ADDENDUM NUMBER THREE

Convert the Squash/Rball CT into Bike Shop
UNIVERSITY OF SOUTH CAROLINA
COLUMBIA, SOUTH CAROLINA

DATE OF ISSUE: May 23, 2014

1 FIRST FLOOR DEMOLITION REFLECTED CEILING PLAN
 SK-A-1 3/16" = 1'-0" REFERENCED ON: A1.1

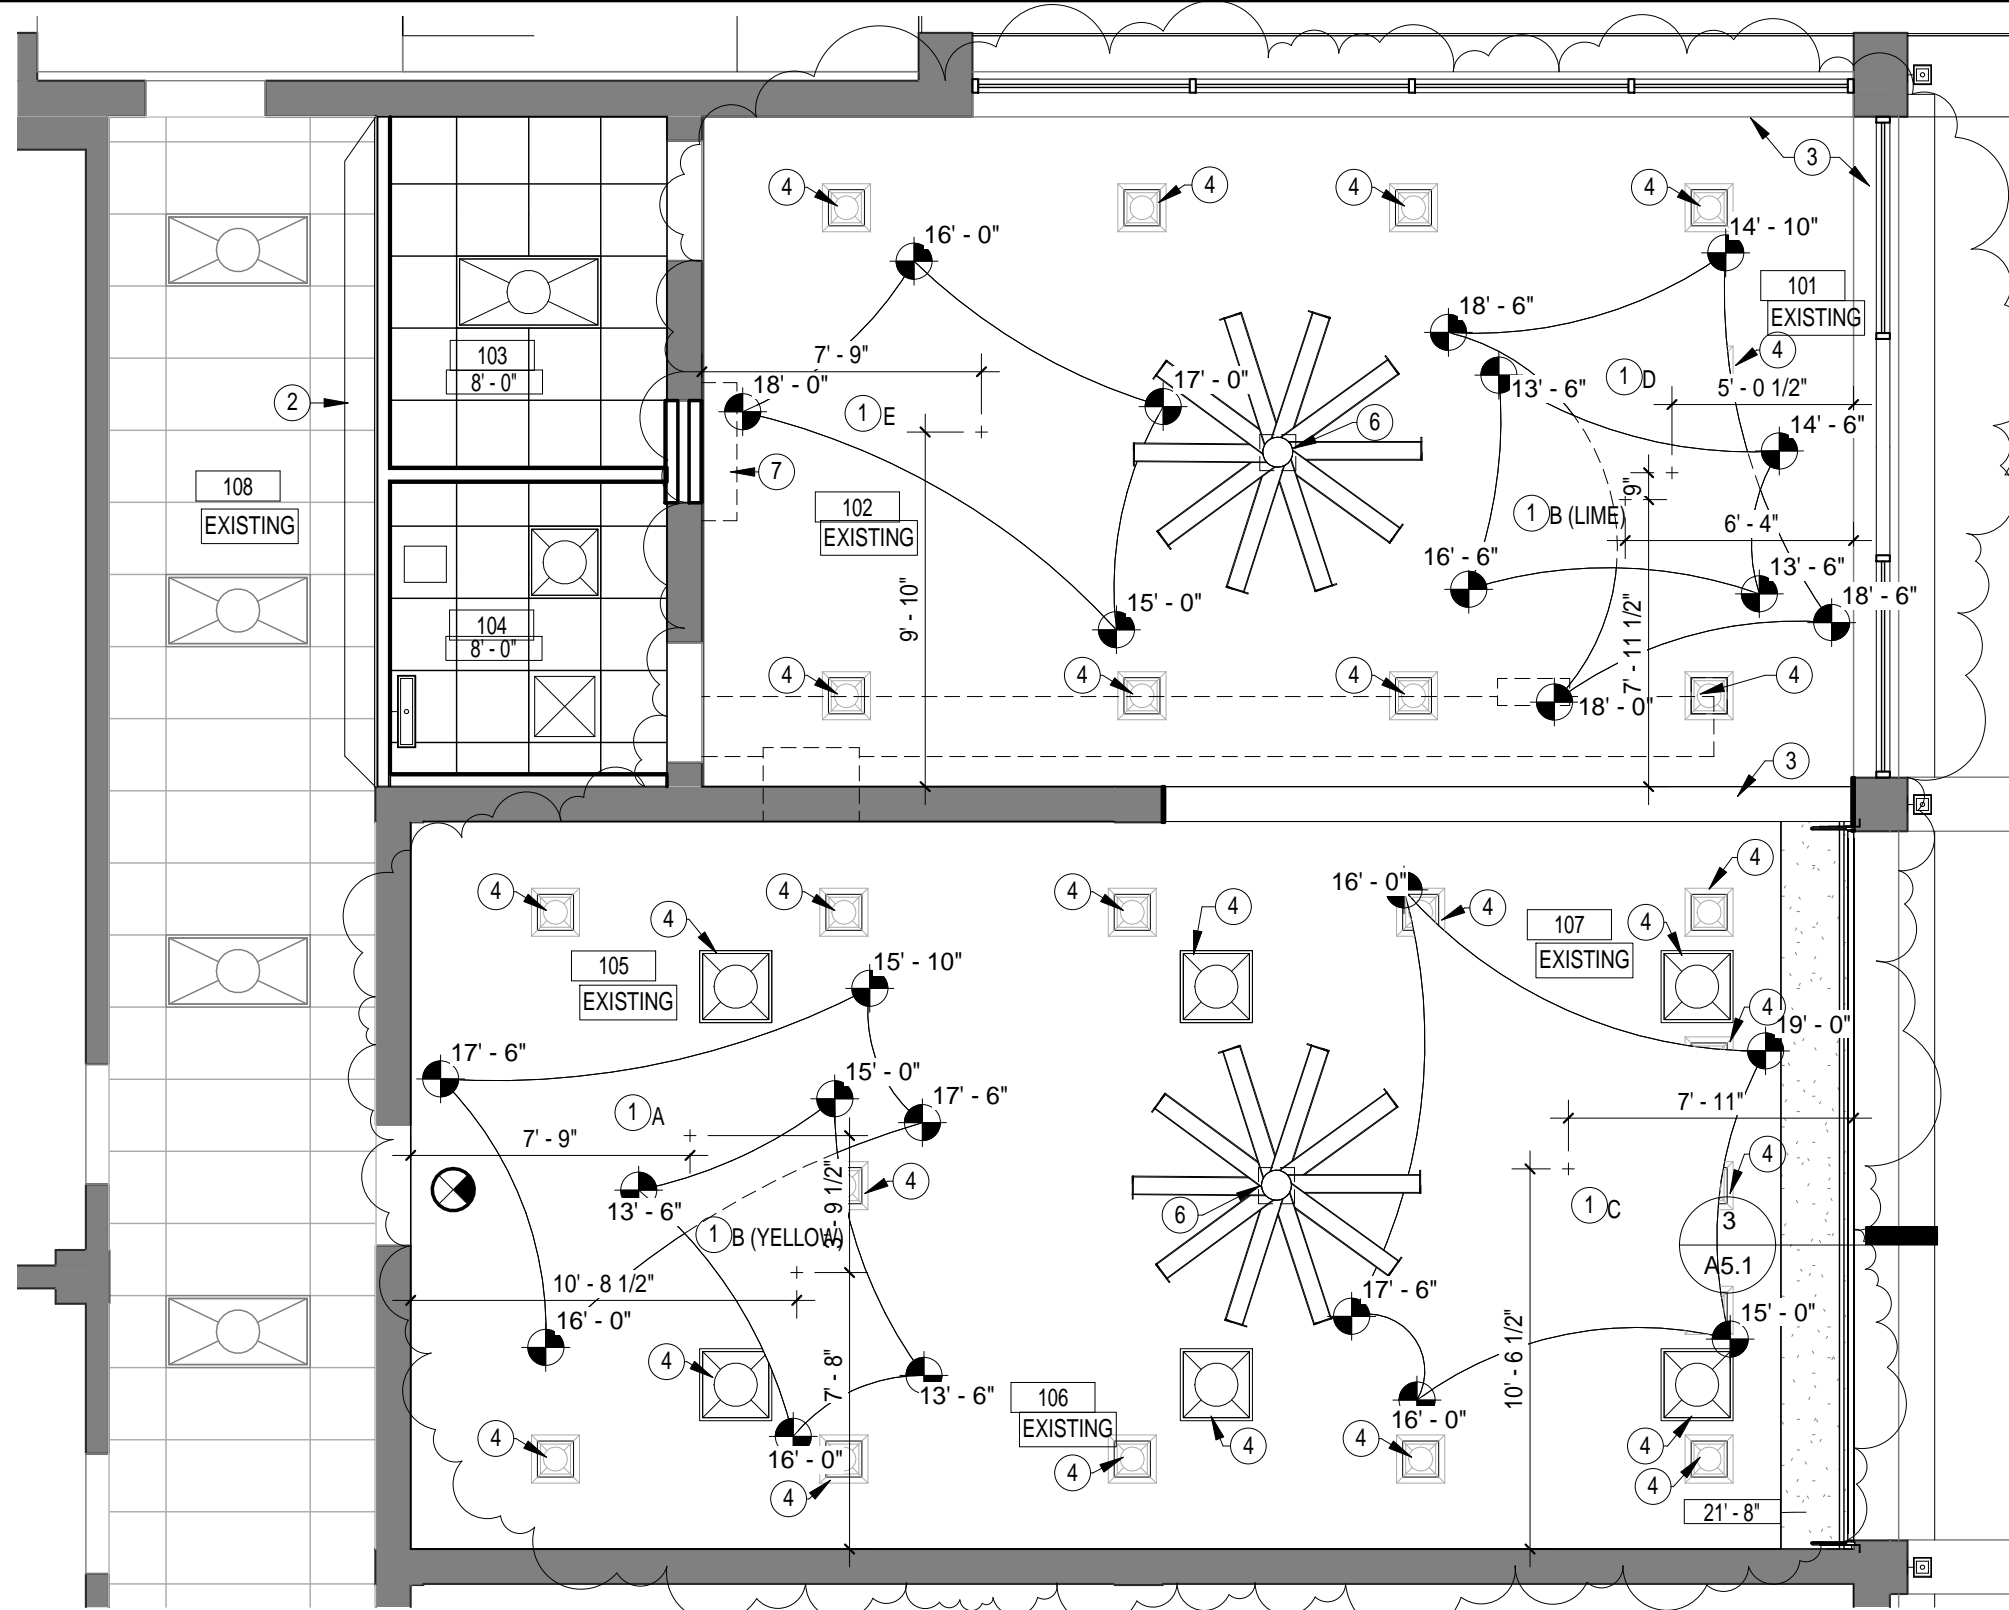
| 3. | <p>Revision: Reference Drawing D2.1 Demolition Reflected Ceiling Plans and A2.1 Reflected Ceilings Plans. See attached SK-A-1 and SK-A-2. Existing Plaster ceiling and lights to remain except where noted for fan installation. See electrical and mechanical for full scope of work.</p> |

ADDENDUM NO. 2 - GENERAL NOTE
 ALL EXISTING LIGHT FIXTURES TO REMAIN EXCEPT AS NOTED FOR INSTALLATION OF NEW FANS. SEE ELECTRICAL AND MECHANICAL.

1 FIRST FLOOR PLAN
SK-A-3 1/8" = 1'-0" REFERENCED ON: A1.1

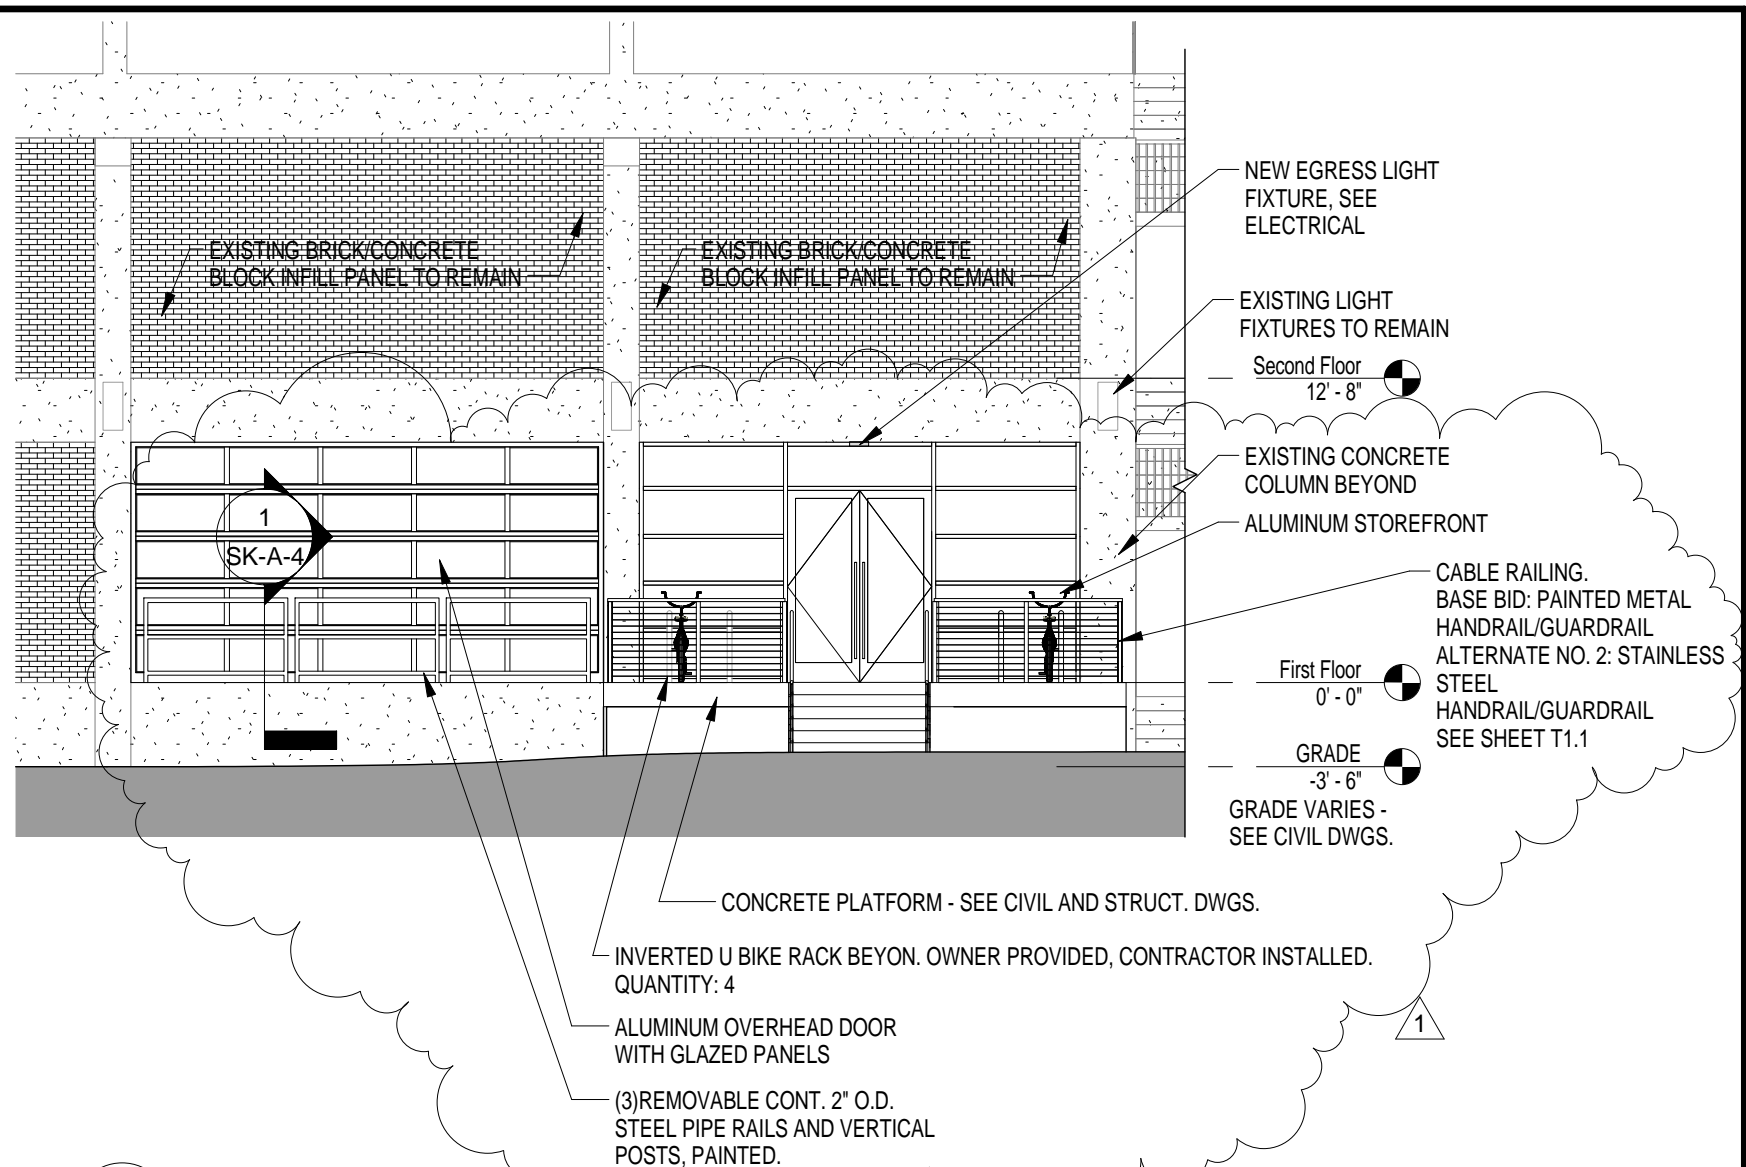
All scope outlined on drawings and described in technical specifications for Convert The Squash/Racquetball Court Into Bike Shop with the following modifications: Provide reduced raised concrete platform, stair, railing and bike racks as shown on SK-A-3 and SK-A-4. Delete concrete ramp as removed by SK-A-3 and SK-A-4. Base Bid revisions shall include all associated work/disciplines including: Delete concrete ramp

| 2. | <p>Revision: Reference All Bid Documents. See SK-A-3 and SK-A-4 for revised Base bid scope.</p> |

BASE BID:
ALL SCOPE OUTLINED ON DRAWINGS AND DESCRIBED IN TECHNICAL SPECIFICATIONS FOR CONVERT THE SQUASH/RACQUETBALL COURT INTO BIKE SHOP WITH THE FOLLOWING MODIFICATIONS: PROVIDE REDUCED RAISED CONCRETE PLATFORM, STAIR, RAILING, AND BIKE RACKS AS SHOWN ON SK-A-3 AND SK-A-4. BASE BID REVISIONS SHALL INCLUDE ALL ASSOCIATED WORK/DISCIPLINES INCLUDING:
DELETE CONCRETE RAMP AND REDUCE RAISED PLATFORM, SEE C1.0, C2.0, C3.0, C4.0 AND REDUCE RAISED CONCRETE PLATFORM.
DELETE CONCRETE RAMP AND REDUCE RAISED CONCRETE PLATFORM, SEE S1.1 AND S1.2. ADJUST FOOTINGS TO REDUCED RAISED PLATFORM AS SHOWN ON SK-A-3, AND SK-A-4.
DELETE LIGHT FIXTURE HE ASSOCIATED WITH CONCRETE RAMP (QUANTITY 3), SEE E2.0.
AT DETAIL 3/E2.0 REPLACE "BODINE MODEL: ELI-250-SD OR EQUAL" WITH THE FOLLOWING, "BODINE MODEL: ELI-20 OR EQUAL."

2 EAST ELEVATION
SK-A-3 1/8" = 1'-0" REFERENCED ON: A1.1

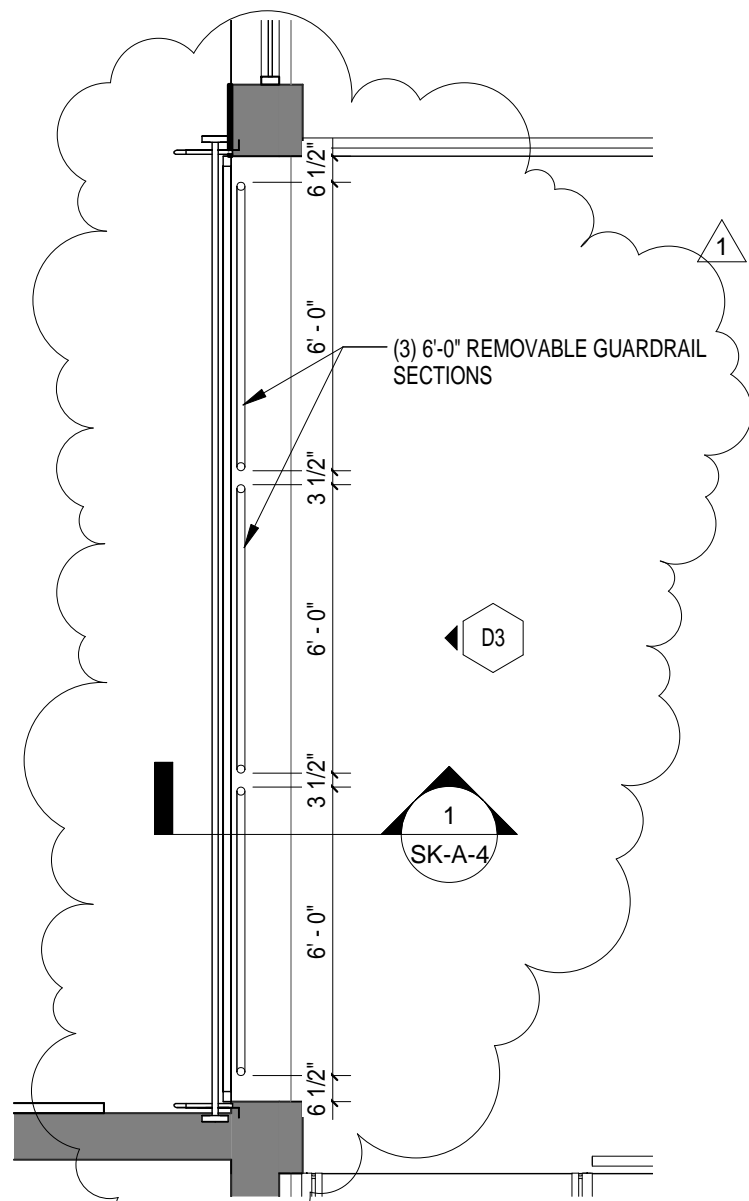
DASHED LINES INDICATE SCOPE OF ALTERNATE NO. 3 WORK INCLUDING EXTENDED RAISED CONCRETE PLATFORM AND CONCRETE RAMP.

ADD ALTERNATE NO. 3.
PROVIDE EXTENDED RAISED CONCRETE PLATFORM, STAIR, RAMP, RAILING AND BIKE RACKS AS SHOWN ON SHEETS A1.1, A4.1, AND A9.1. PROVIDED EXTENDED RAISED CONCRETE PLATFORM AND RAMP AS SHOWN ON C1.0, C2.0, C3.0, AND C4.0. PROVIDED EXTENDED RAISED CONCRETE PLATFORM, RAMP AND FOOTINGS AS SHOWN ON S1.1 AND S2.1. PROVIDED EXTERIOR LIGHTING (HE FIXTURE, QUANTITY 3) AT CONCRETE RAMP AS SHOWN ON E2.0. PROVIDE DETAIL 3/E2.0 AS SHOWN ON SHEET E2.0.

SK-E-1

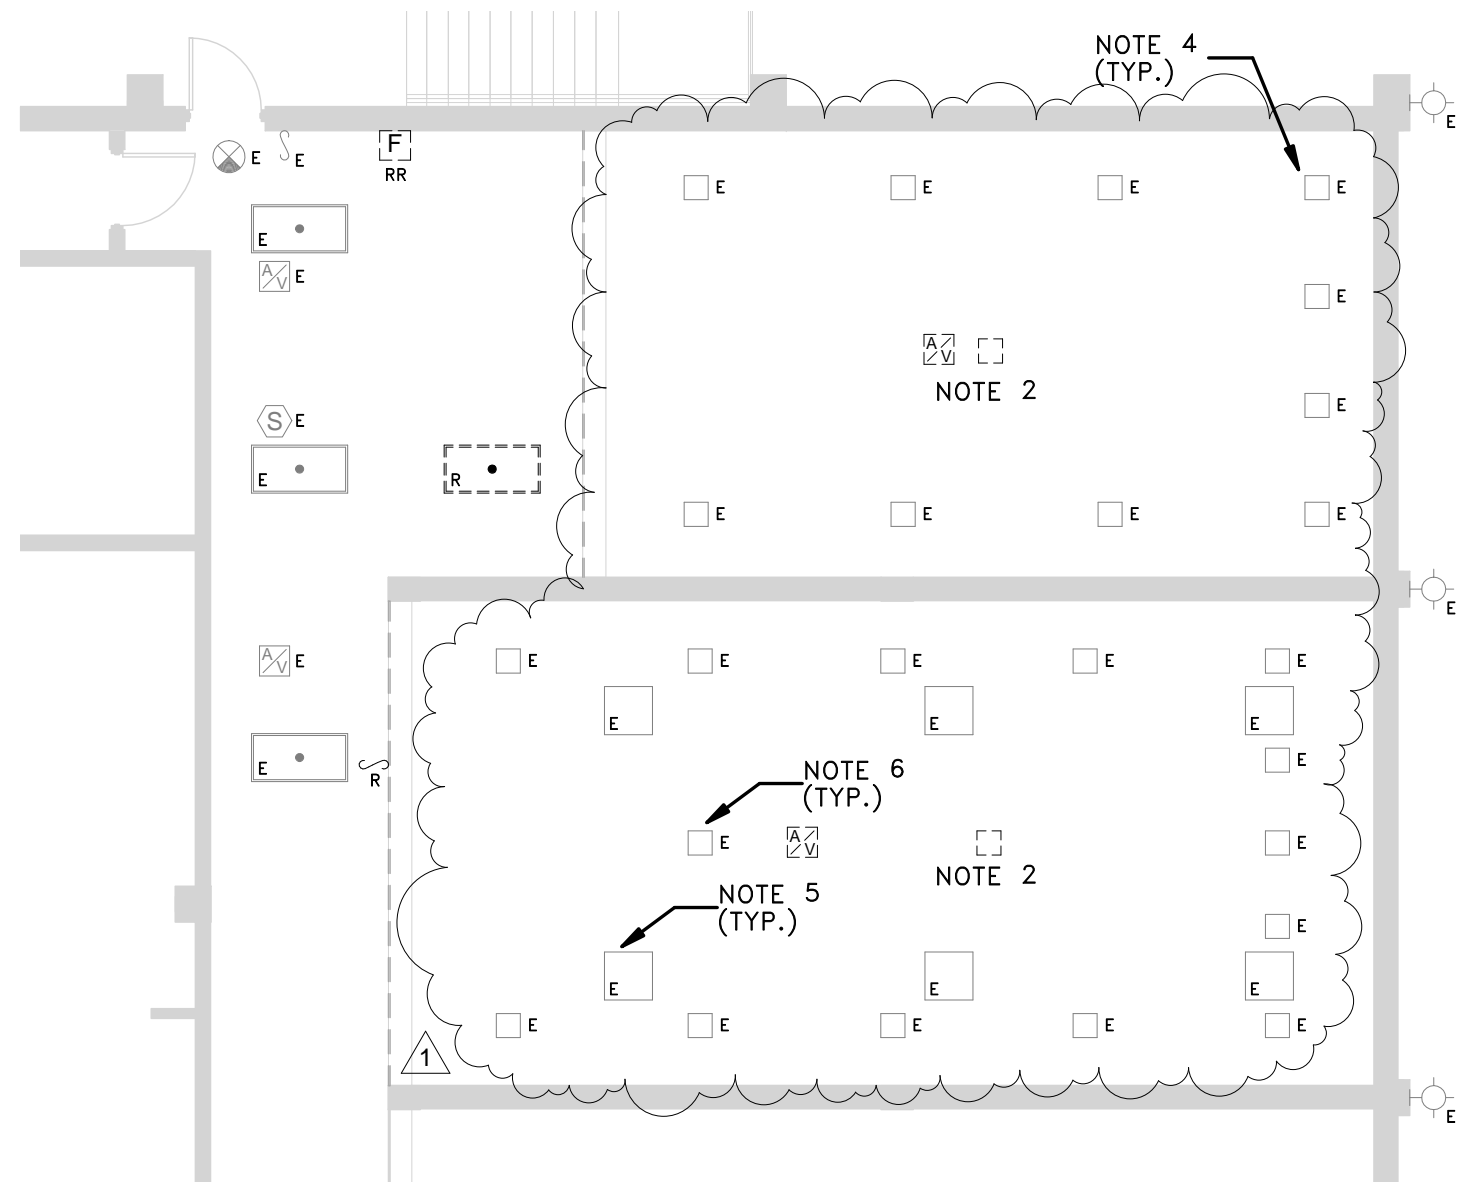
| 4. | <p>Revision: Reference Drawing E1.0 Electrical Demolition Plans and E2.0 Electrical Renovation Plans. See attached SK-E-1, SK-E-2, SK-E-3, AND SK-E-4. Existing Plaster ceiling and lights to remain except where noted for fan installation.</p> |
